**Initial Comments of the National Rural Electric Cooperative Association
Energy Conservation Standards for Distribution Transformers
Notice of Proposed Rulemaking
Docket No. EERE-2010-BT-STD-0048
RIN 1904-AC04
April 3, 2012**

Figure 1
Balancing Area/Marginal Cost Pricing
Hour 16

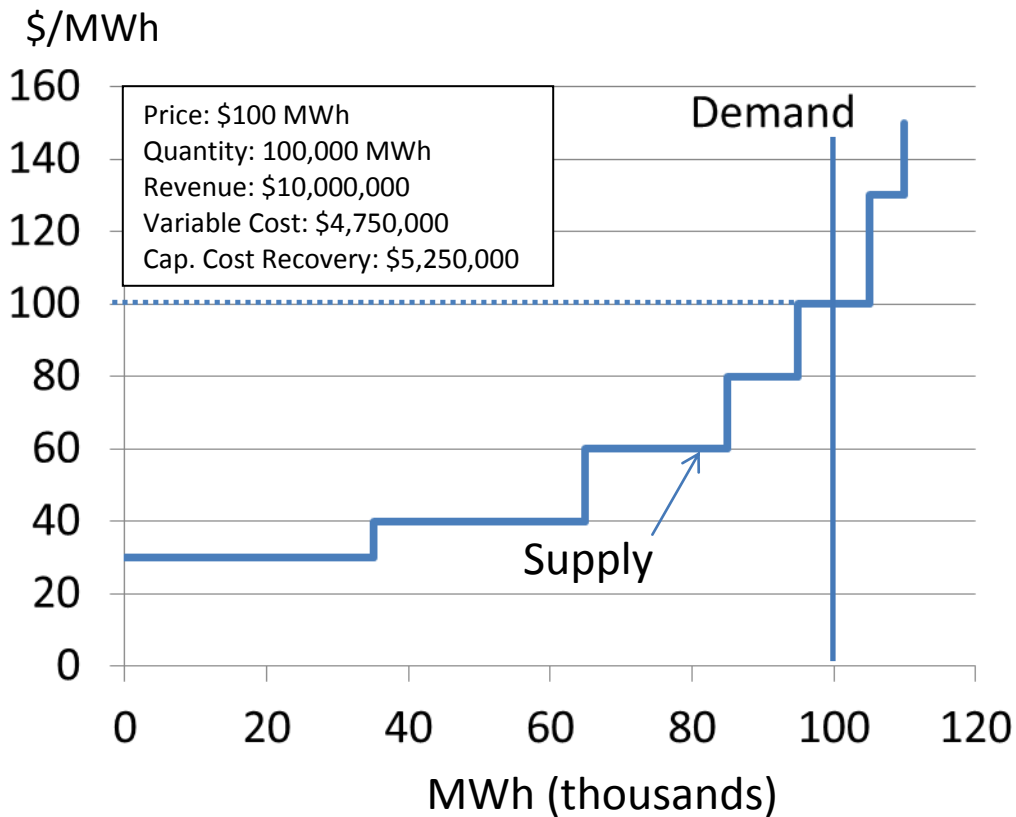
Figure 1 provides an explanation of how this works. It depicts the supply and demand conditions in a large balancing area or market during hour 16 of a given day. The demand is 100,000 MWhs. The marginal cost of the last generator required to meet hourly demand is \$100/MWh (10 cents/kWh). This is the selling price that all

dispatched generators receive. Total revenues for this one hour of operation are \$10 million. However, the sum of the variable costs of all dispatched generators is \$4.75 million. The remaining \$5.25 million goes toward the recovery of fixed capacity costs and profit. In this way, the FERC Form 714 hourly and market prices recover both variable and fixed capacity costs. Demand charges are not needed to collect capacity charges. These costs are already included in the hourly energy prices.¹⁰ NRECA does not support assigning any demand charges for transformers when these costs are already being collected through marginal cost pricing.
